Harnett County Environmental Health

EXISTING SYSTEM APPROVAL

Proposed Property Improvement: In Ground Pool Addition with Decking

EXISTING SYSTEM APPROVAL SITE SKETCH

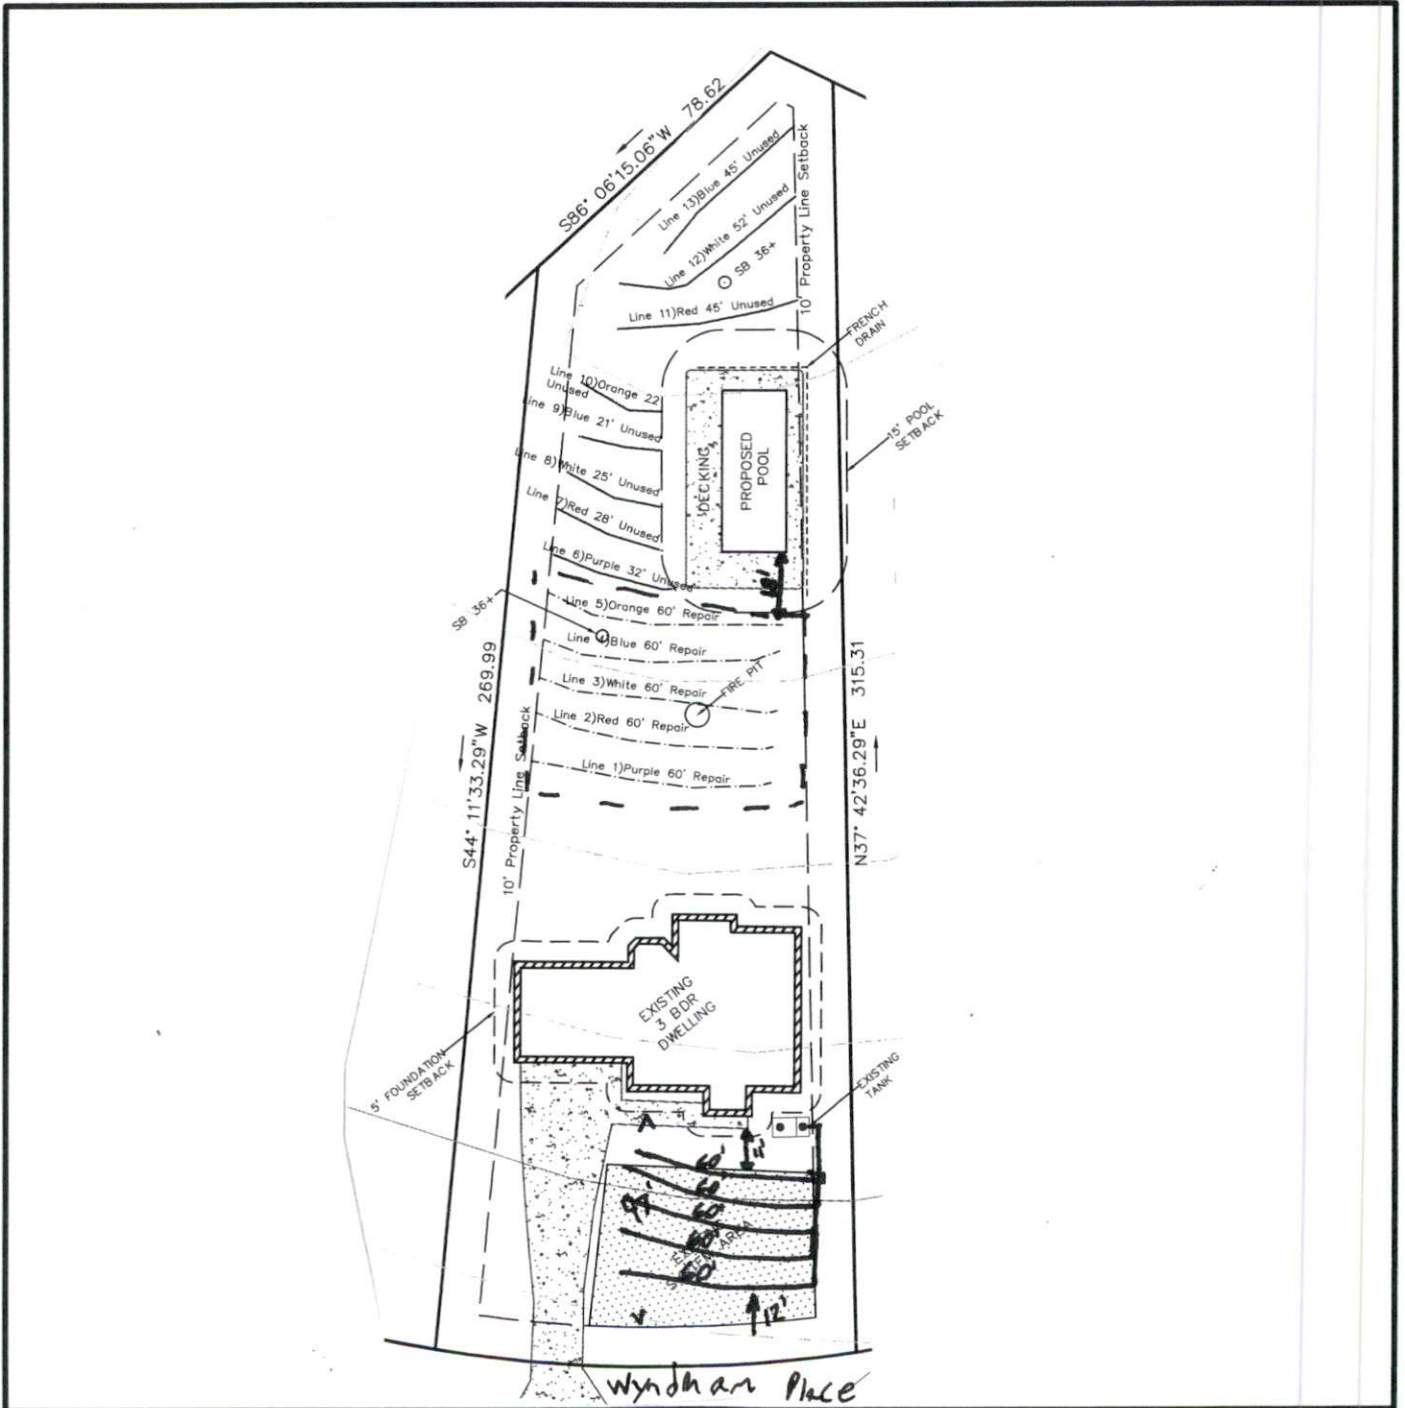
Approval Conditions: The Decking around the pool may not exceed more than 10' feet on any side of pool.

The Repair area needs to stay 15' away from in ground pool and 5' from decking foundation. Fire pit to be removed when repair is needed.
